SOLICITATION ADDENDUM NO. 2
ITB 19-0036
Terra Linda Re-Pipe and Restroom Remodel

Note: The drawing set was issued to Washington County for building permit approval on 1/6/2020. Plan check comments were received and responded to as "Delta 1" on 2/10/2020. The plan check response sheets are included as part of this package.

TERRA LINDA ELEMENTARY SCHOOL RE-PIPE AND RESTROOM REMODEL

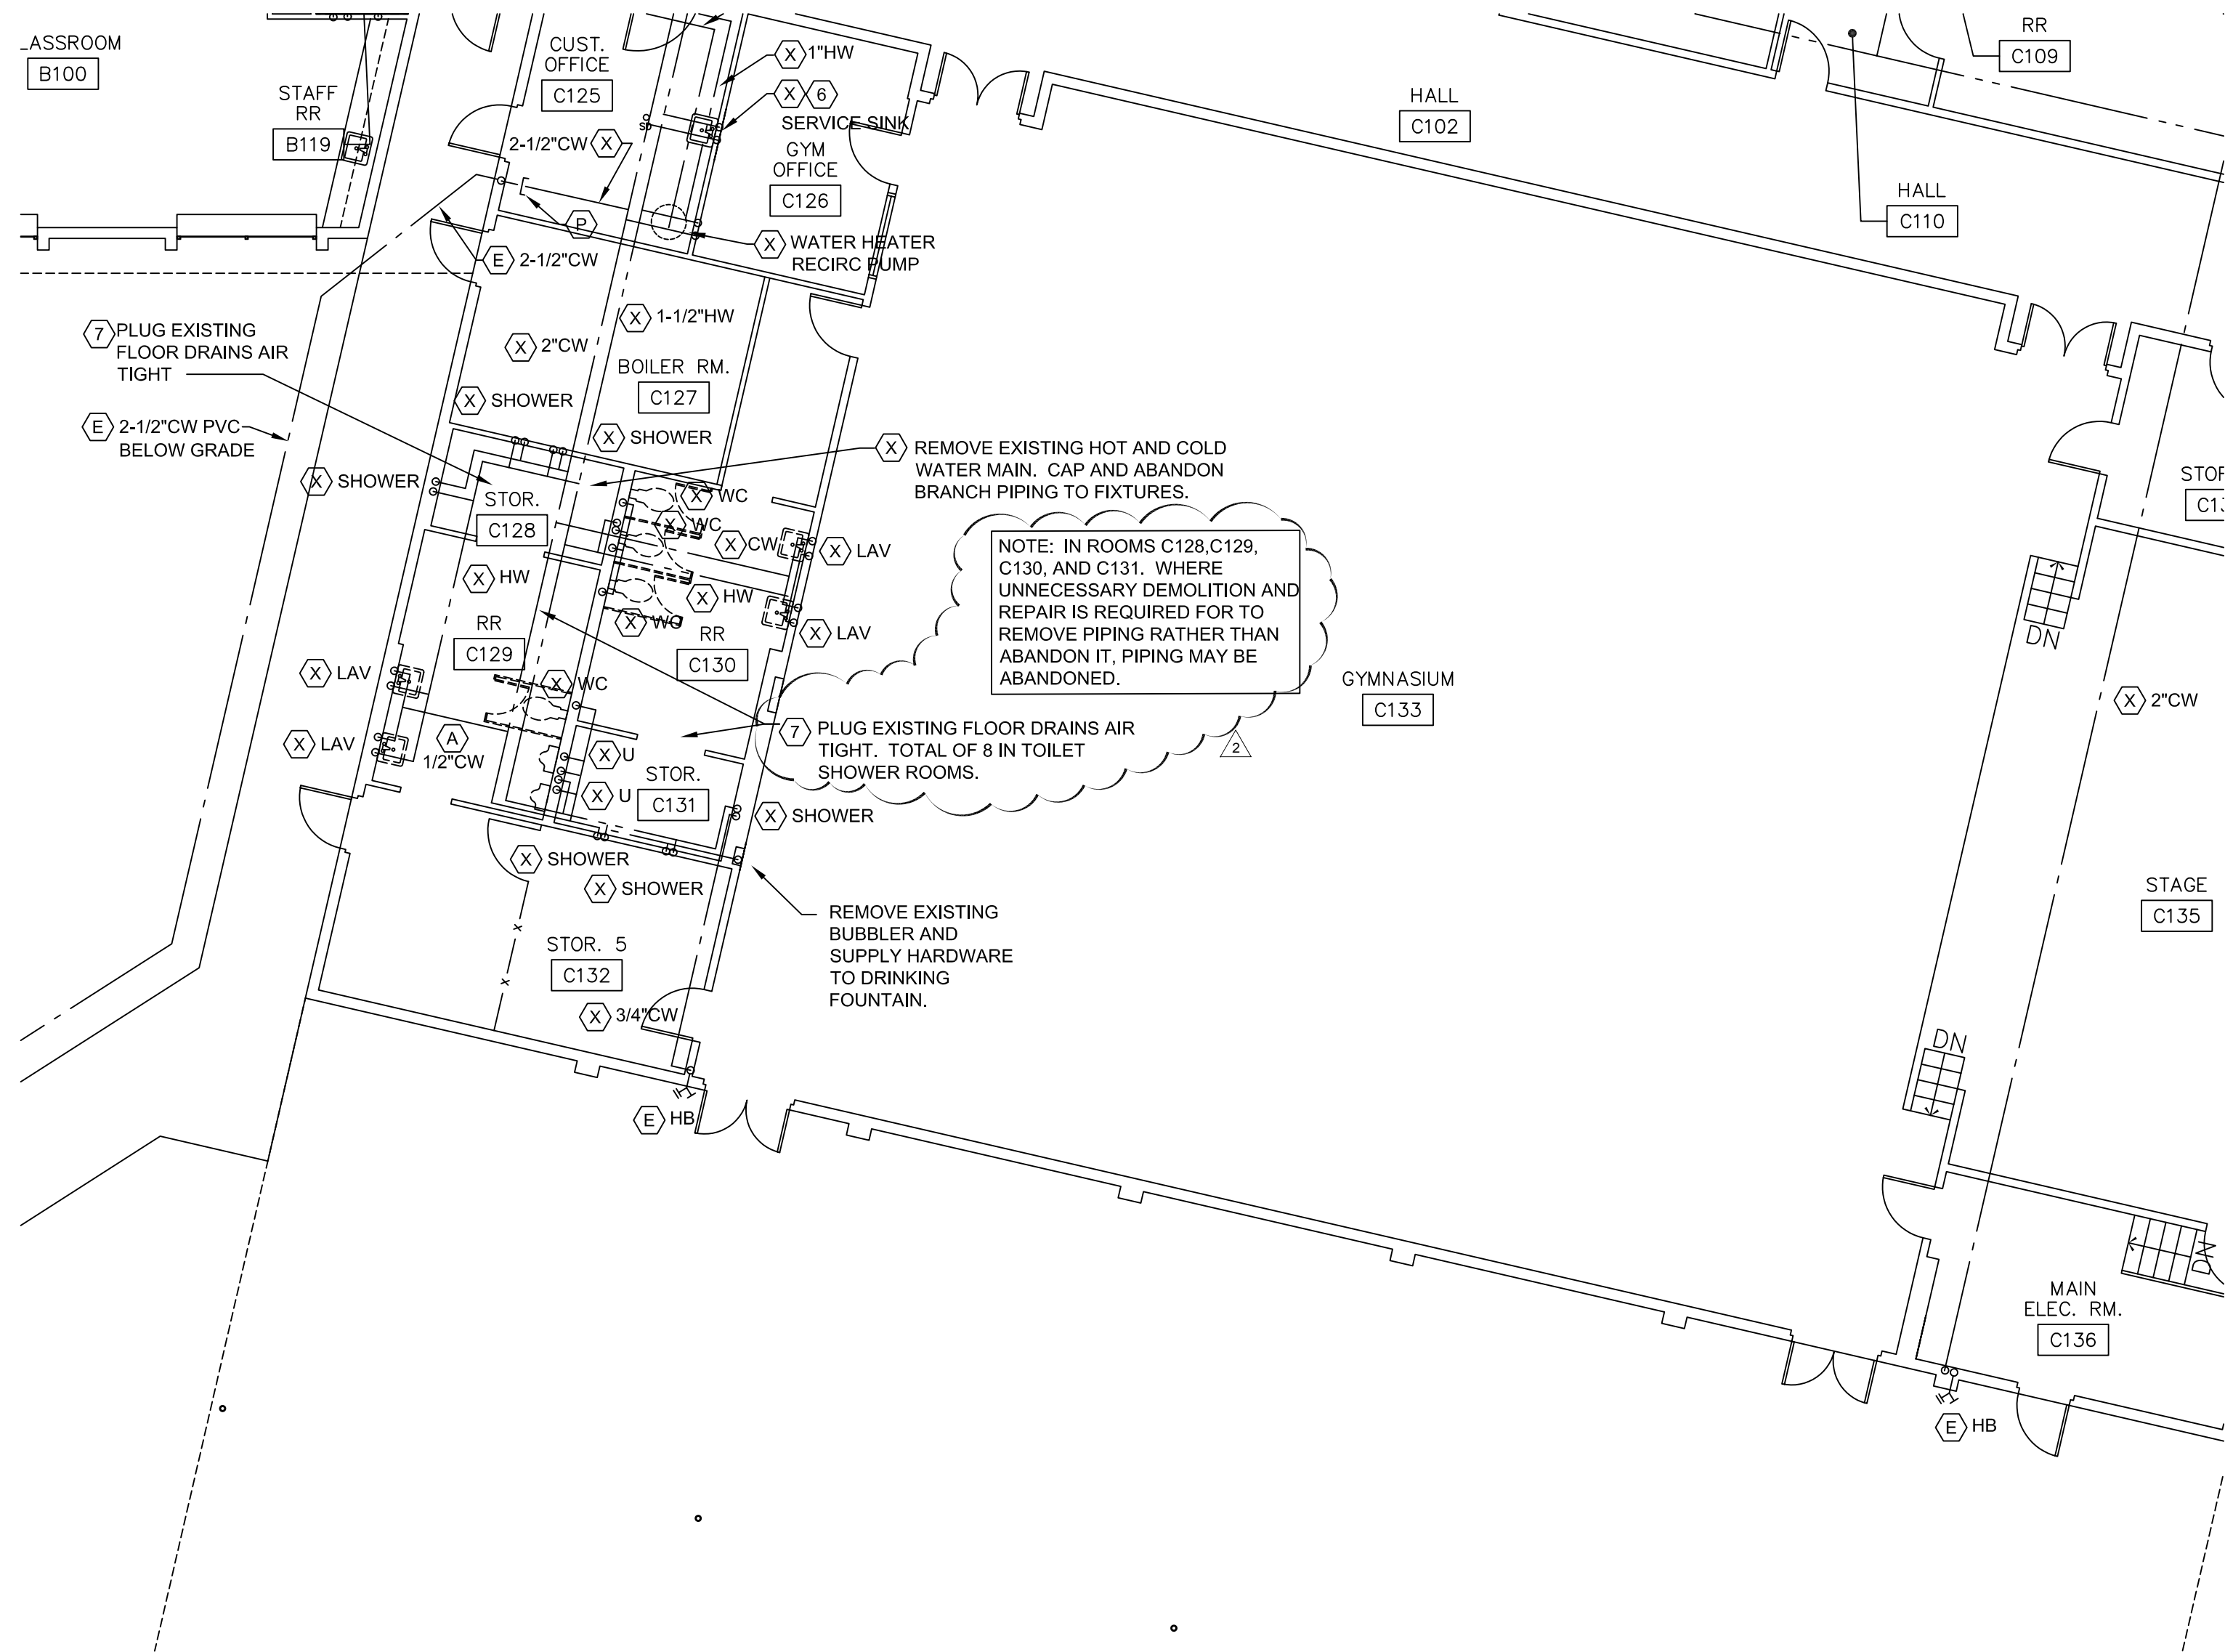
Question: Can we shut down water to the entire building for the duration of the project? If needed we could have 1 hose bib working.
Answer: The building's domestic water may be shut down for construction, provided temporary water is supplied as required for construction purposes. (Language is to be provided on Sheet P0.1 – see Drawings section below)

Question: What are the specs for the double check valve and vault P2.2
Answer: Double check valve, Watts 757 series or equal, same size as line size. Utility vault sized as required for installation. (Language is to be provided on Sheet P0.1 – see Drawings section below)

<u>HWRP-3</u>	DOMESTIC HOT WATER CIRCULATING PUMP: IN-LINE, OIL LUBRICATED, WITH 3/4" SWEAT HALF UNION. 3 GPM AT 11 FEET OF HEAD. PROVIDE WITH AQUASTAT BASIS OF DESIGN: GRUNDFOS UP 15-35 SFC	115 VOLT, 1.70 AMPS 1 PH 1/22 HP
<u>HWRP-3</u>	DOMESTIC HOT WATER CIRCULATING PUMP: IN-LINE, OIL LUBRICATED, WITH 3/4" SWEAT HALF UNION. 3 GPM AT 11 FEET OF HEAD. PROVIDE WITH AQUASTAT BASIS OF DESIGN: GRUNDFOS UP 15-35 SFC	115 VOLT, 1.70 AMPS 1 PH 1/22 HP
<u>DCVA-1</u>	DOUBLE CHECK VALVE ASSEMBLY, TWO INDEPENDANT CHECK MODULES IN SINGLE HOUSING, SLEEVE ACCESS PORT, FOUR TEST COCKS, TWO SHUTOFF VALVES. PROVIDE IN GROUND VAULT FOR SIZED FOR ASSEMBLY. BASIS OF DESIGN: WATTS 757 SERIES OR EQUAL, SAME SIZE AS LINE SIZE. VAULT TO BE UTILITY VAULT OR EQUAL.

P1.3

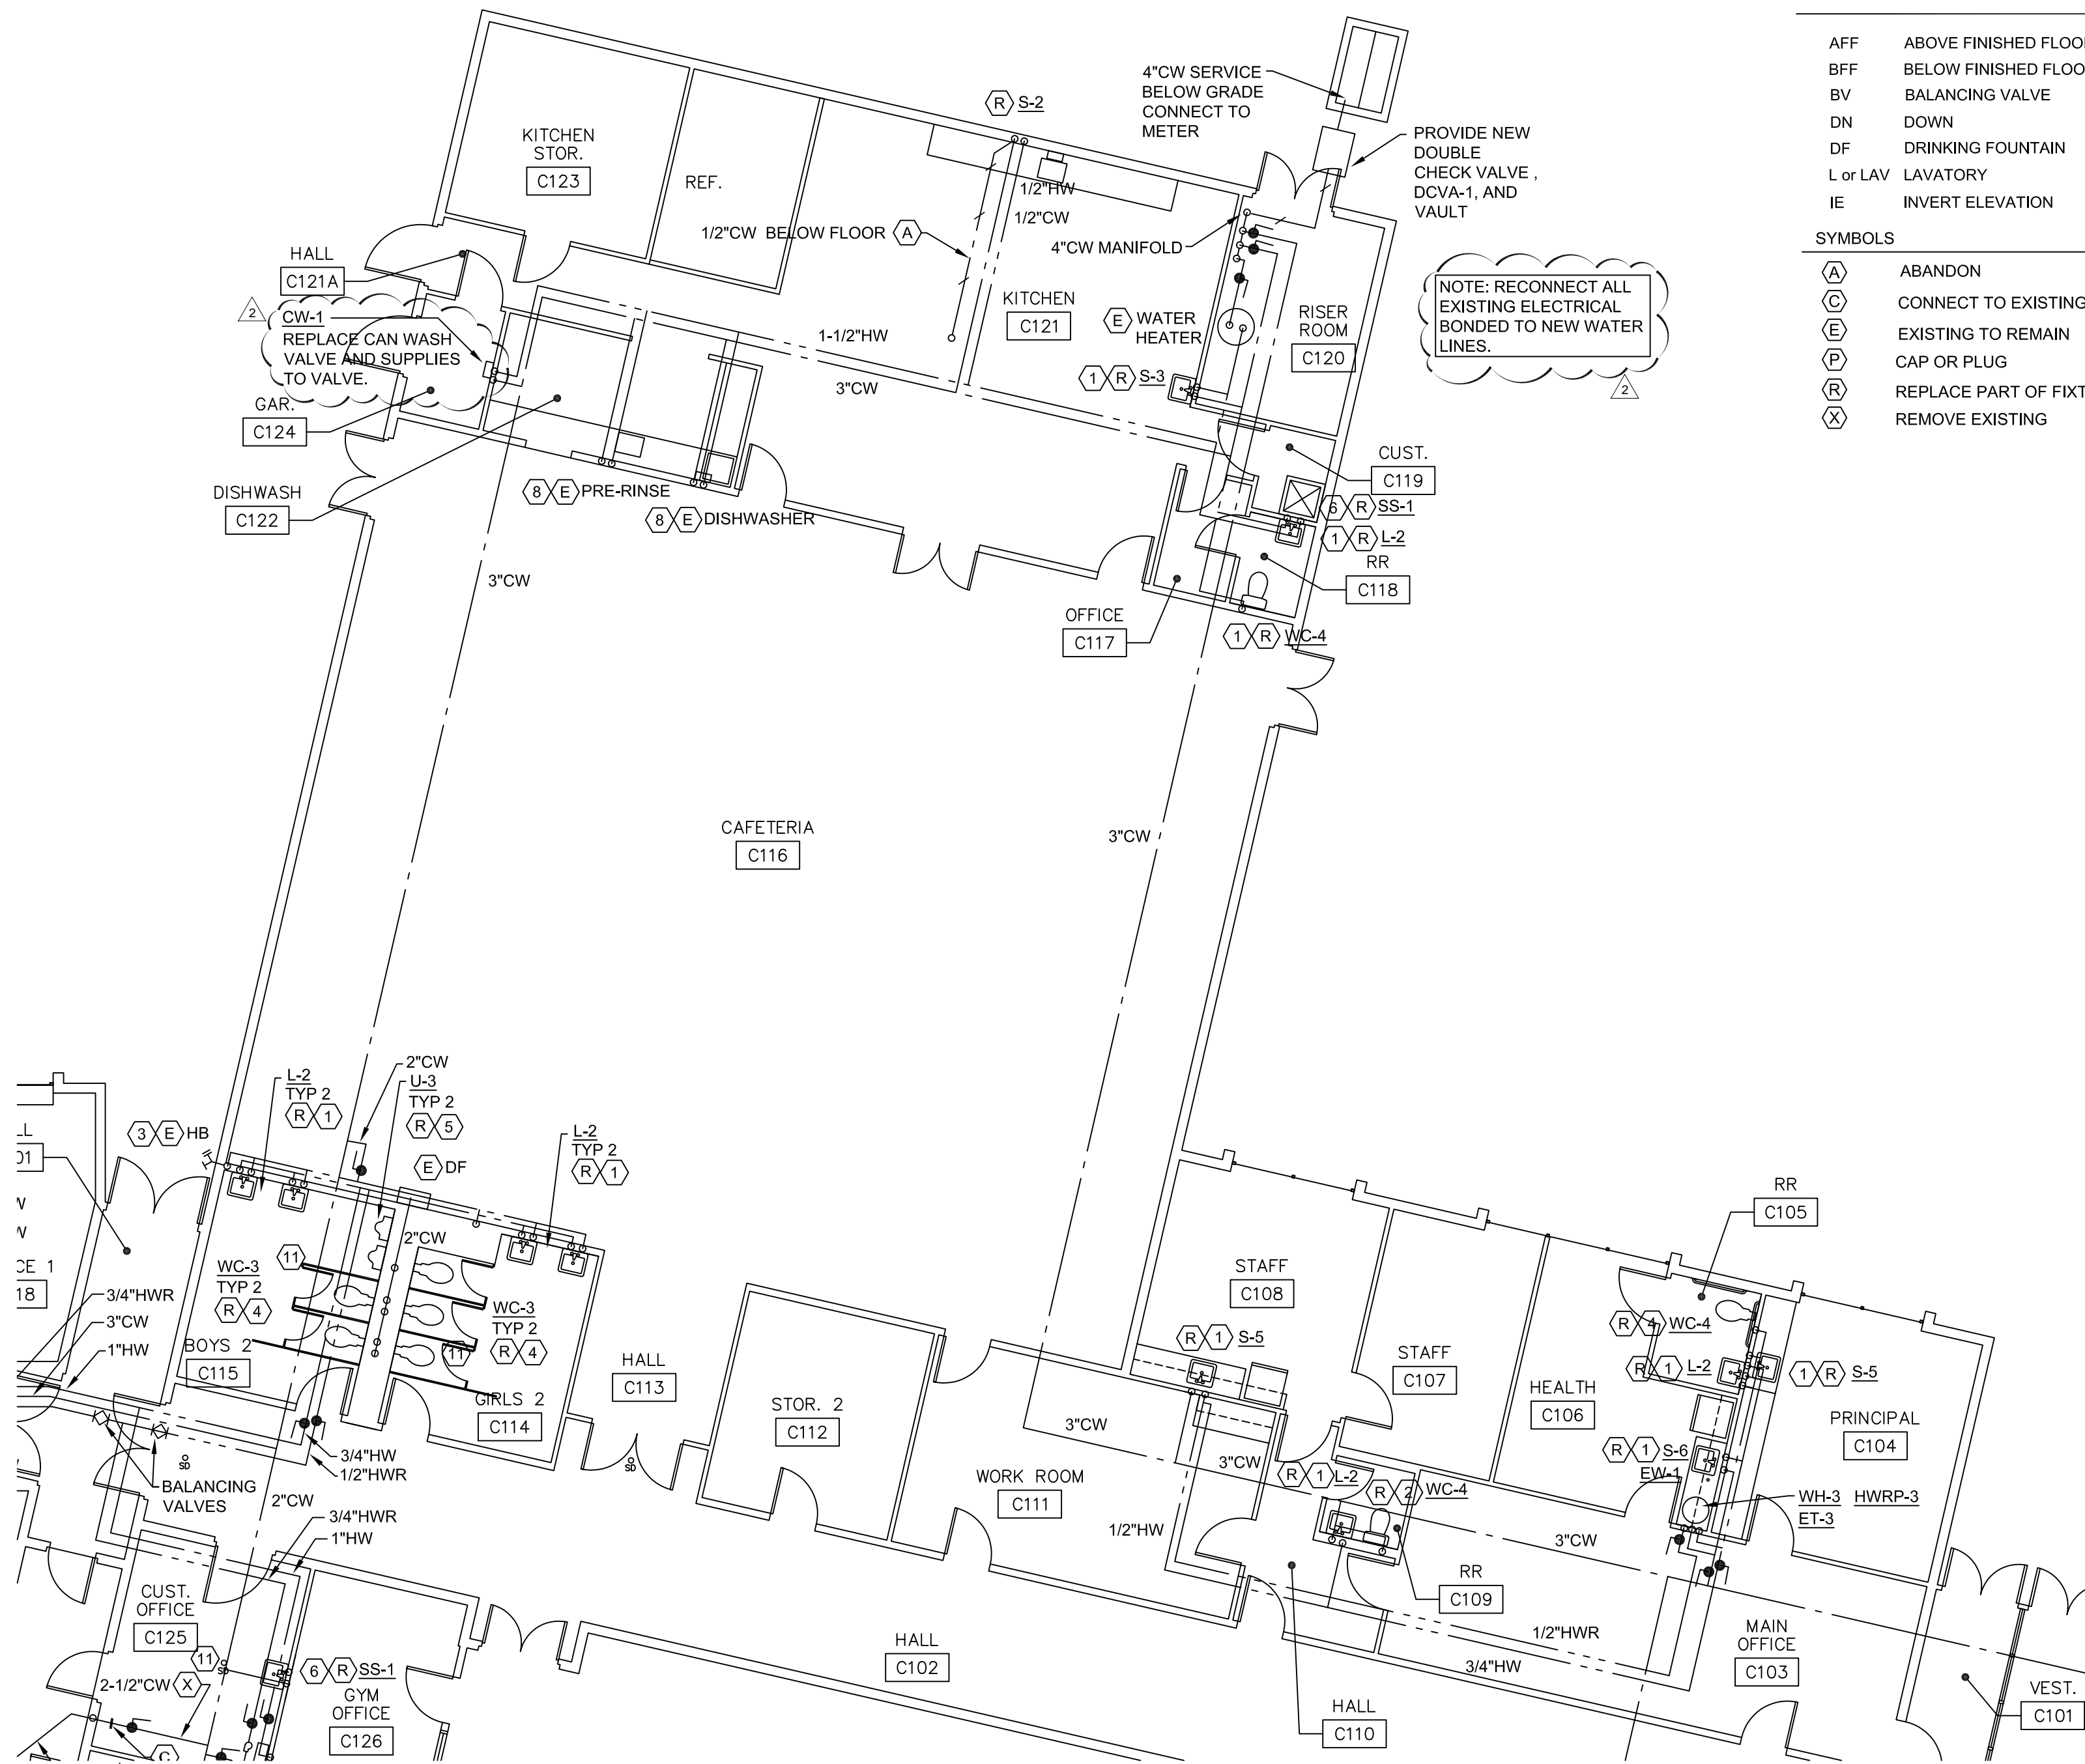
Question: How many floor drains are to be assumed in C128 & C131?
Answer: Total of 8 floor drains. (Language is to be provided on Sheet P1.3 – see Drawings section below)

Question: Can we abandon piping not necessary to chase?
Answer: In rooms C128, C129, C130 and C131, where unnecessary demolition and repair is required to remove piping rather than abandon it, piping may be abandoned. (Language is to be provided on Sheet P1.3 – see Drawings section below)
